Re Objections to Planning Application Reference No. 2016/2507/P, Proposed Development at 150 Haverstock Hill, London.

Below are my comments to the planning application for change of use, part demolition and addition of a floor, rear roof terrace and solar panels on 150 Haverstock Hill.

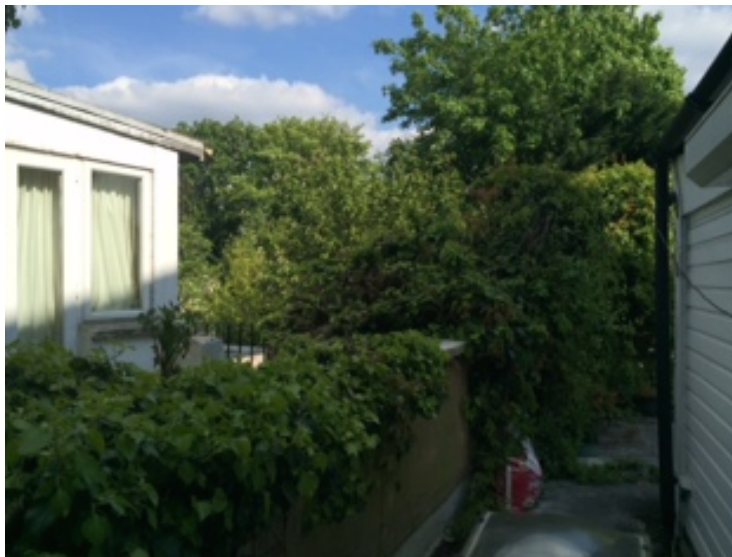
Around 2/3 of the **front** wall (left side) and the **left side** wall for all three floors of 150a is built in to 152, sharing ground floor with the drycleaners, first floor with 152C and second floor partially with 152 B.
